# Access Compliance Report

## Public Rights-of-Way

### (Curb Ramps)

Intersection ID: 27404	Main Street: BALLANTYNE COMMONS PY	Cross Street: MEADOW RUN LN	Location: SE
ADA ID: 174D761178C5	Ramp Type: Perp	Initial Pass/Fail: Fail	Overall Compliance: No
		Severity Score: 8.75	
Codes/Mitigation Info/Possible Solution		Field Measurements/Component Compliance

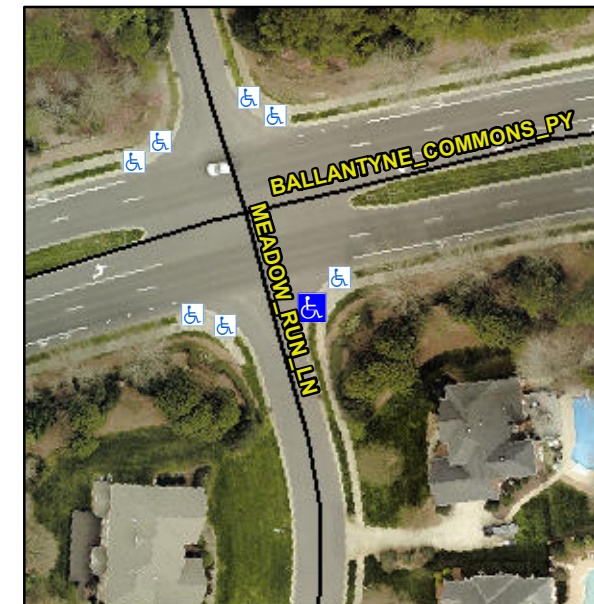
**Remove & Replace Entire Ramp.**

**Not Found, R304.5.1**

Compliance	Description	Data	Compliance	Description	Data
N/A	Ramp Length (in)	69.0	Yes	Ramp Slope (%)	7.5
No	Ramp Width (in)	43.5	Yes	Ramp XSlope (%)	0.5
N/A	Flare Type LT	N/A	N/A	Flare Type RT	N/A
N/A	Flare Slope LT (%)	N/A	N/A	Flare Slope RT (%)	N/A
N/A	Flare Traversable LT?	N/A	N/A	Flare Traversable RT?	N/A
N/A	Landing Length (in)	N/A	N/A	DWS Provided?	N/A
N/A	Landing Width (in)	N/A	N/A	DWS Contrast?	N/A
N/A	Landing Slope (%)	N/A	N/A	DWS Length (in)	N/A
N/A	Landing X Slope (%)	N/A	N/A	DWS Full Width?	N/A
N/A	Landing Curb? (Y/N)	N/A	N/A	DWS Offset (in)	N/A
N/A	Shared Landing?	N/A			
N/A	Gutter Ponding?	N/A	N/A	Gutter Slope (%)	N/A
N/A	Gutter Lip Ht (in)	N/A	N/A	Gutter X Slope (%)	N/A
N/A	Painted X Walk1?	No	N/A	Painted X Walk2?	N/A
	X Walk 1 Direction	To W		X Walk 2 Direction	N/A
N/A	X Walk 1 Width (in)	N/A	N/A	X Walk 2 Width (in)	N/A
	X Walk 1 Slope (%)	1.9		X Walk 2 Slope (%)	N/A
	X Walk 1 X Slope (%)	0.4		X Walk 2 X Slope (%)	N/A
